PROPOSED DEVELOPMENT AT 30 FAIRLIGHT STREET FAIRLIGHT 2094

DA 2021/2034 BY APPLICANT 30 FAIRLIGHT PTY LIMITED

All photos taken from upper level balcony of Unit 3/1 Berry Ave.

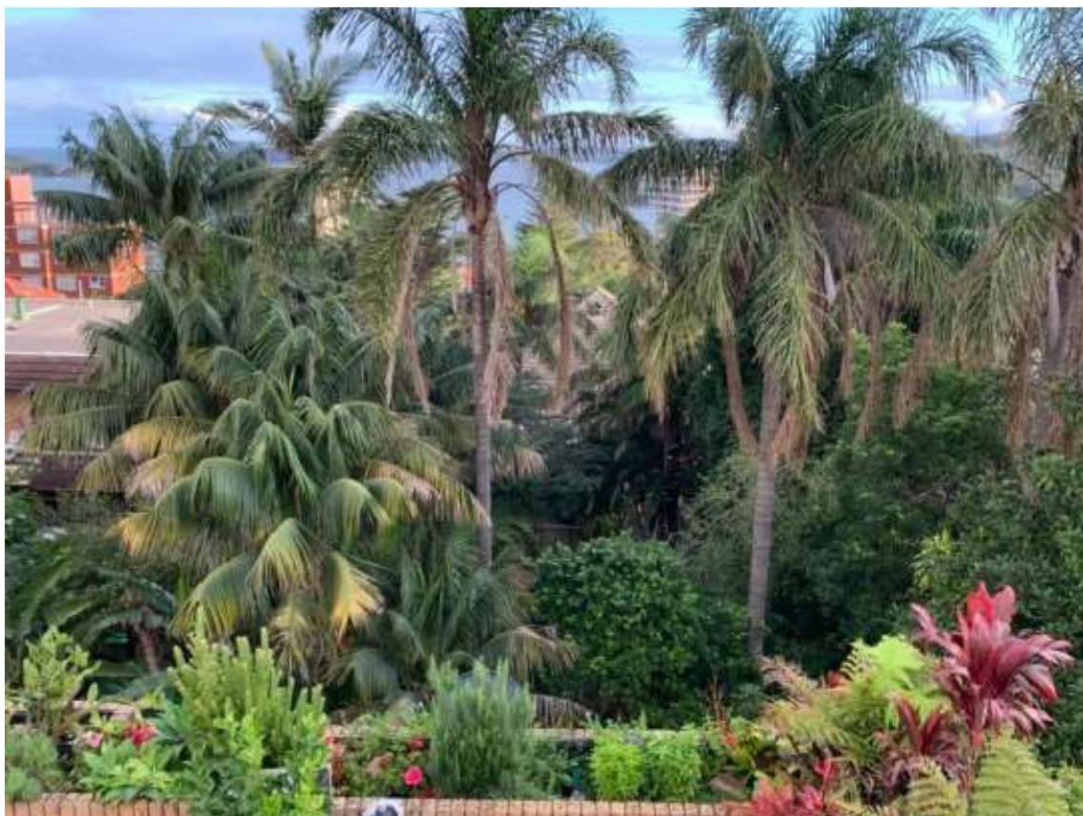
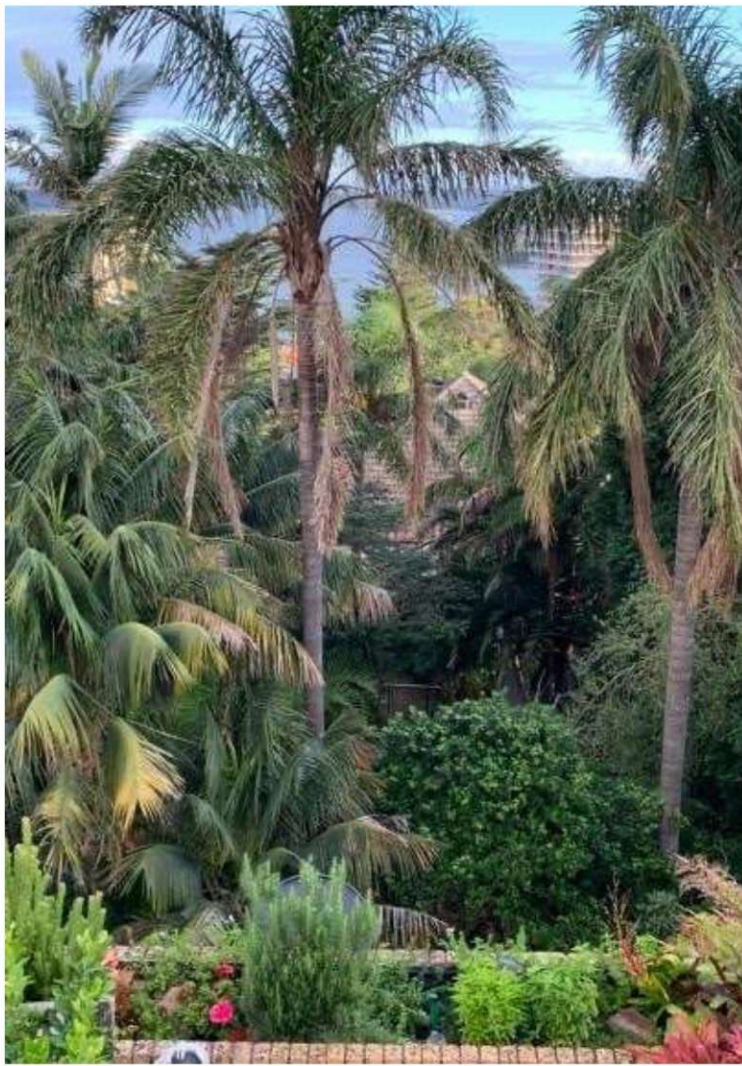
1 Berry Avenue features roof terraces that overlook the site from the North. There appears to be significant risk of view loss caused by the proposed building exceeding height limits. To illustrate this

we attach photos from our balcony to prove this. We currently enjoy magnificent water & horizon views interspersed with beautiful trees & why should we lose this from a developer trying to fit so much on a small residential block to maximise his return at our loss. Not acceptable. Height poles will confirm the top level is unacceptable, exceeds Planning height regulations to any fair minded Council, as it will prove invasive to neighbours & totally non-compliant.
